SERVICE BULLETIN 43

SUBJECT: POSSIBLE INCORRECT CABLE THIMBLE INSTALLATION

APPLICATION: All Glasair I, Glasair II, and Glasair III aircraft shipped prior to 10/08/87.

FIGURE (1)

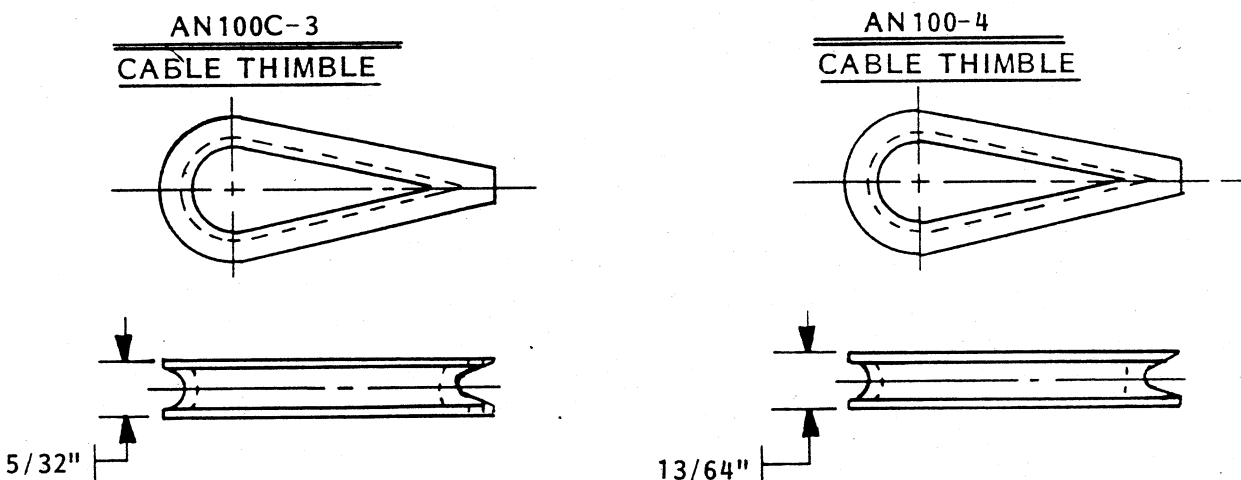
We have discovered that, in recent Glasair kits, we have inadvertently been supplying AN100C-3 cable thimbles in place of AN100-4 cable thimbles. The AN100C-3 is intended to be used only with 3/32" diameter cable. If an AN100C-3 thimble is used in place of an AN100-4 thimble on the larger 1/8" diameter cable, the cable would not rest uniformly in the thimble groove and could be weakened by bearing against the sharp edges of the groove.

There is very little external difference between the AN100C-3 cable thimble and the AN100-4 cable thimble. The significant difference is the width of the cable opening of the thimble, as shown in FIGURE (1).

NOTE: The outside dimensions of the cable thimbles are shown in FIGURE (1) because it would be difficult to measure the inside dimensions if the thimble has already been installed in a cable assembly.

SOLUTION: We have no way of determining who may have received the incorrectly labeled cable thimbles and are therefore asking all Glasair builders to inspect all cables thimbles in their kit or on their aircraft to verify that the correct thimbles have been supplied and installed.

If, after inspecting the cables, an incorrect cable thimble is found to be installed, the thimble must be replaced. This requires removing the cable and cutting the 18-3M Nicopress sleeve to remove the thimble.

Inspect the cable thimbles supplied with your kit, referring to FIGURE (1) to determine their sizes.
